# Keystone RV Company

## SAFETY ADVISORY # 20-389

### Cougar Inverter Wiring

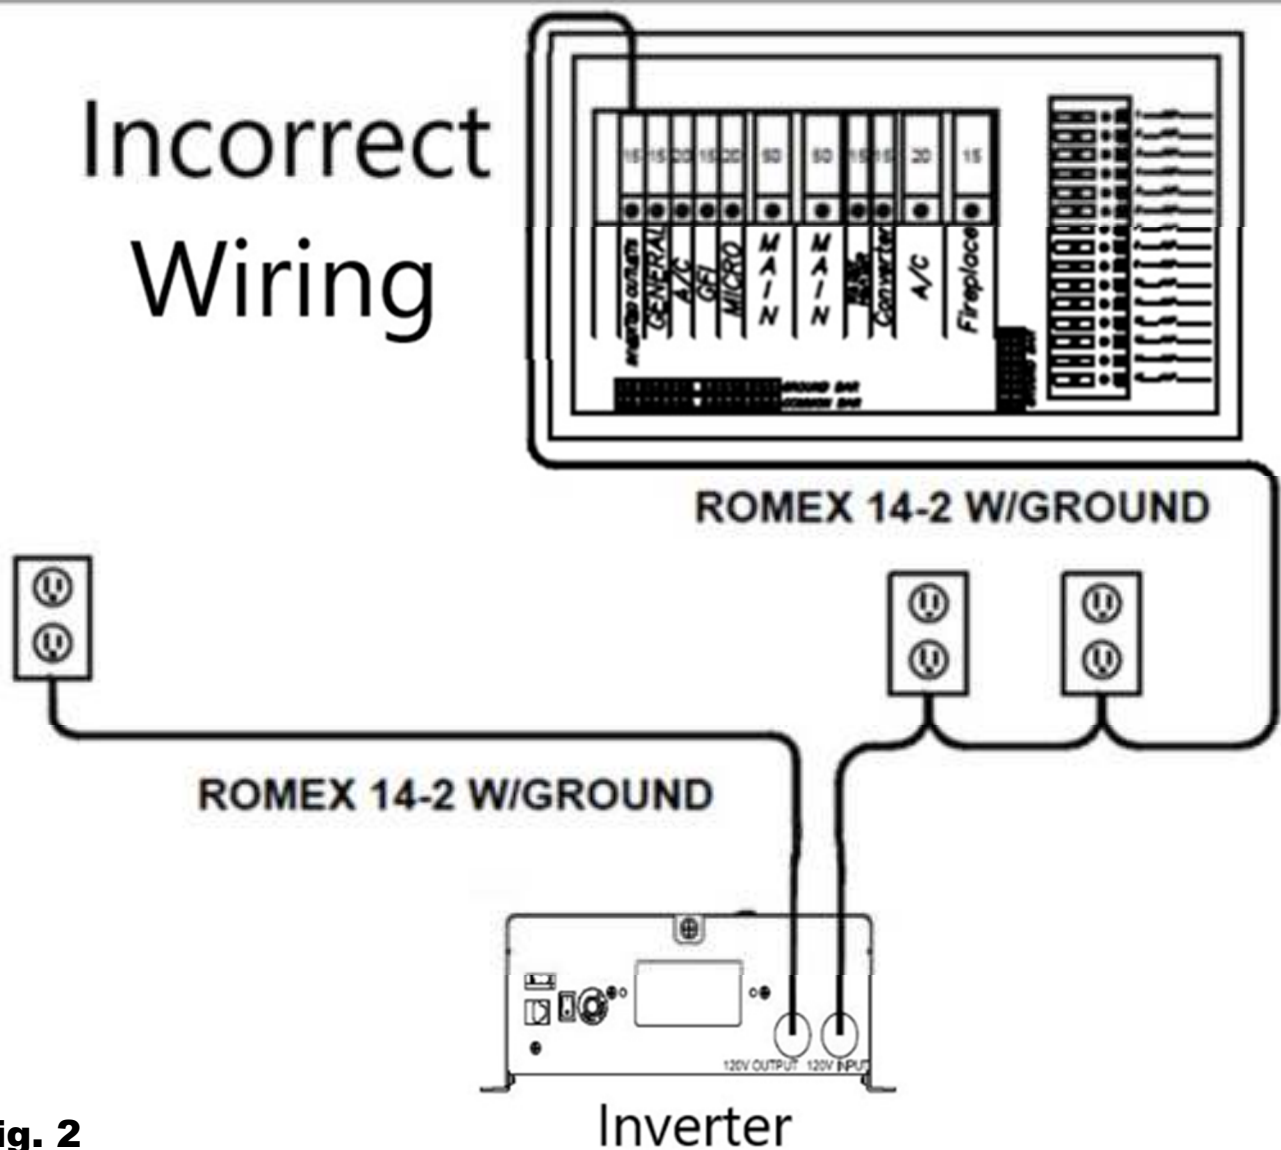
With a fully charged battery connected; disconnect the shore power and turn on the inverter. Inspect outlets labeled “Off the Grid Inverter Circuit”. These should be the only 120VAC circuits energized in the unit. See Figure 1. If these are the only circuits energized proceed to Warranty Reimbursement for inspection only, otherwise proceed to Step 3.

**Fig. 2**

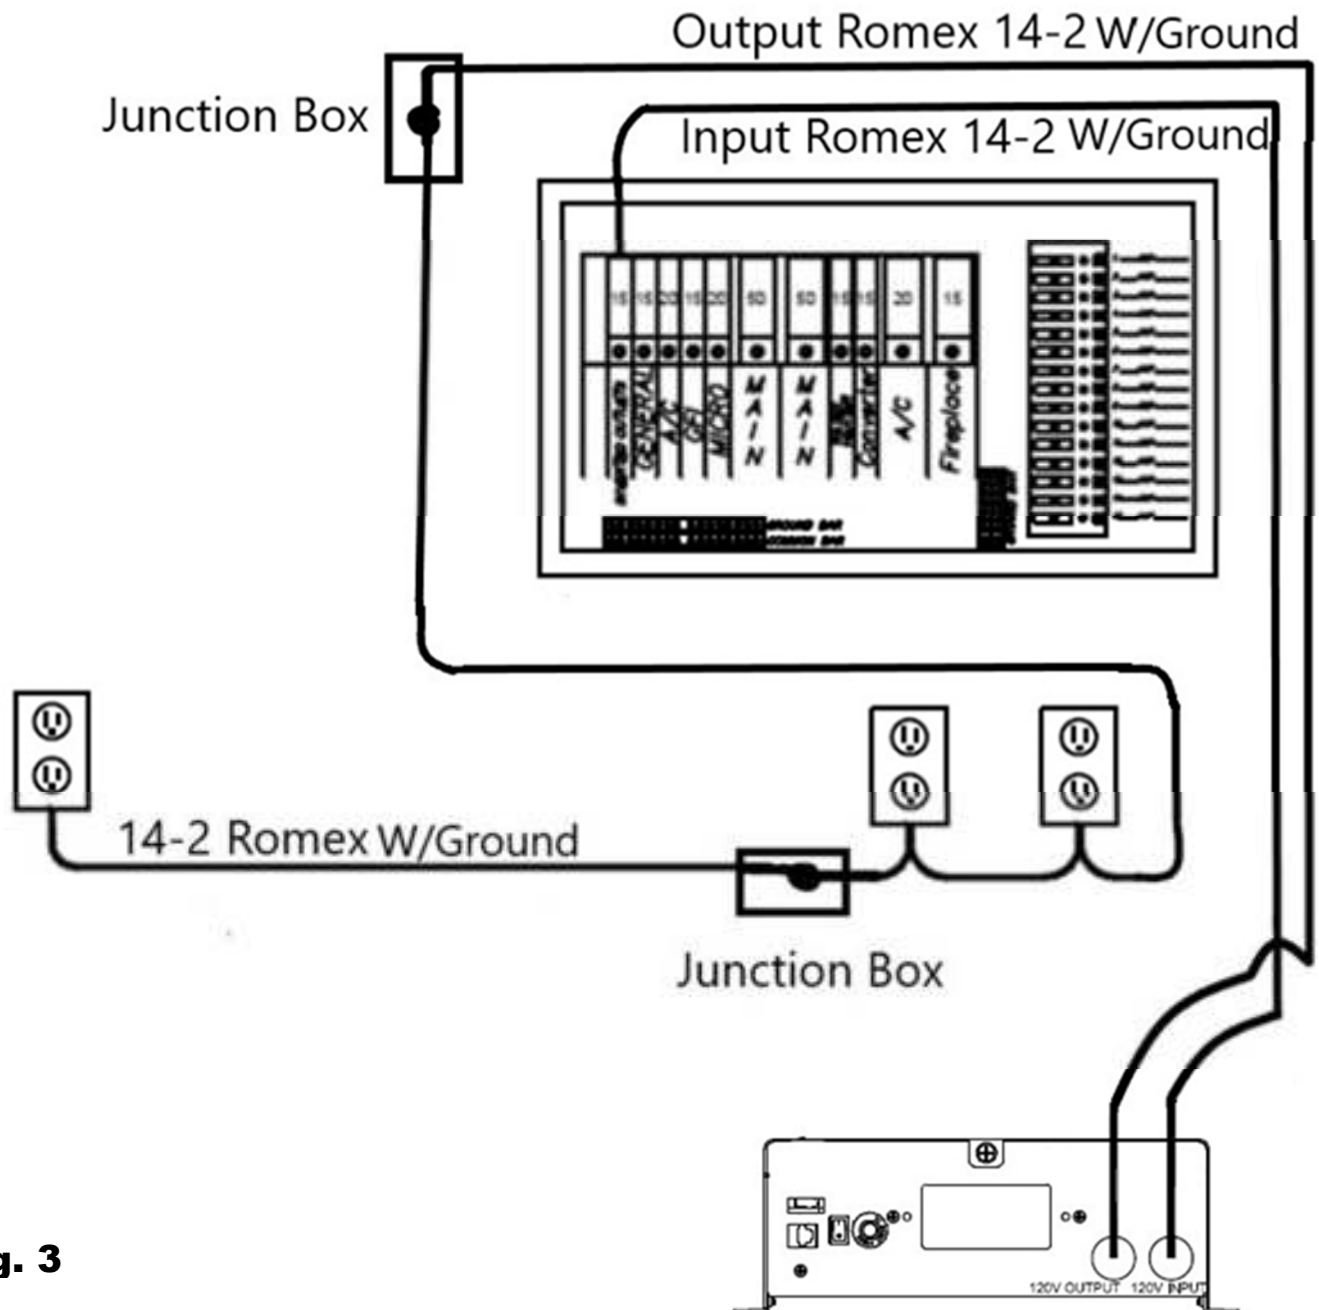
Only West Coast units with Serial numbers starting with LCXXXXXX and MCXXXXXX are potentially affected by this scenario. If only one outlet labeled "Off the Grid Inverter Circuit" is energized See Figure 2. Disconnect the 120VAC power and the 12VDC power. Remove the power center and disconnect the wiring to the breaker labeled as "Inverter" along with the neutral and the bare copper wire for this circuit out of the power center.
